Rezoning Transportation Analysis

Petition Number: 2020-054

General Location Identifier: Tax ID 14525501

Revision Log:	Date	Description
	05-18-20	First Review
	06-24-2020	Second Review (KP)

I-77 TYPICAL SECTION

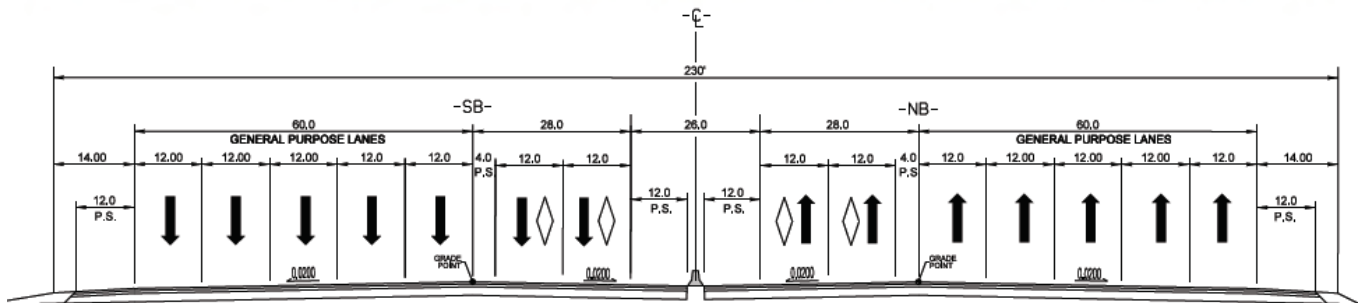
- I-77 Managed Lanes (TIP# I-5718A)
 - Widen existing freeway to ten lanes by constructing four managed lanes (two in each direction) – and rebuild the I-277 (Belk Frwy) interchange.
 - ROW in 2025 and Construction in 2029 (*Subject to change due to NCDOT funding issues*)
 - 2016 feasibility study (TIP #FS-0810A) shows additional ROW needed:
